Service Bulletin

NO:HIFI2-01-001

SUBJECT: Noise Recorded in Analog Recording Mode

MODEL (S): MDS-JE330, MDS-S40

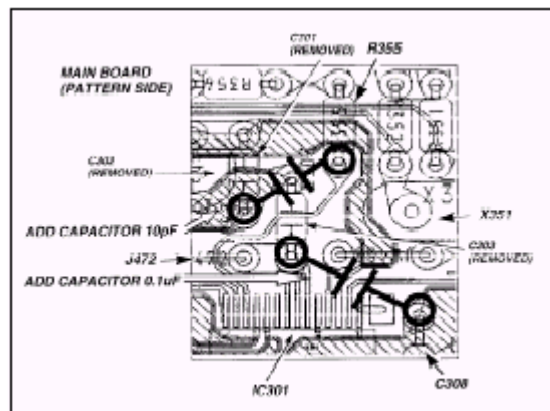
Symptom: The customer complains of noise in the audio when recording in analog recording mode.

Remove capacitors C301, C302 and C303 from the main board.

Add the following:

REF	DESCRIPTION	PART NUMBER
NA	CAPACITOR 10 PF	1-162-232-31
NA	CAPACITOR 0.1 UF	1-164-159-31
